Access Compliance Report

Public Rights-of-Way

Intersection ID: 30436	Main Street: MARIANNES RIDGE RD	Cross Street: STEELE MEADOW RD	Location: NW
ADA ID: 0C905E8C4429	Ramp Type: BlendTrans1	Initial Pass/Fail: Pass	Overall Compliance: No
Severity Score: 10			
Codes/Mitigation Info/Possible Solution		Field Measurements/Component Compliance

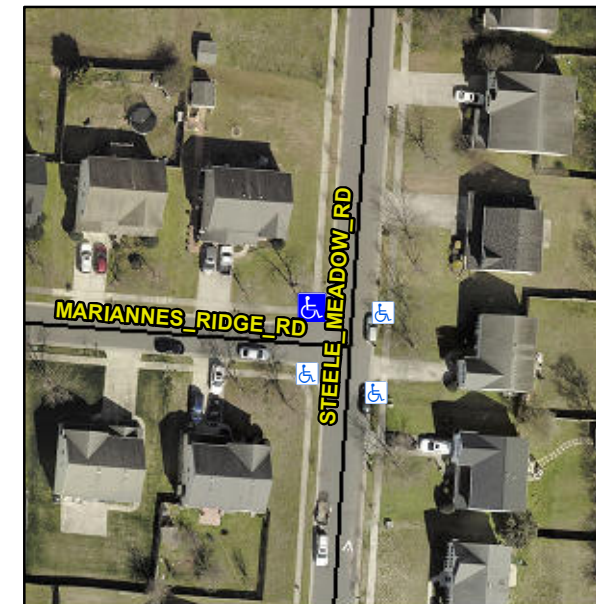
Remove & Replace Curb Ramp With Two New Directional Ramps or Equivalent.

R304.2.1, R304.5.3, R305
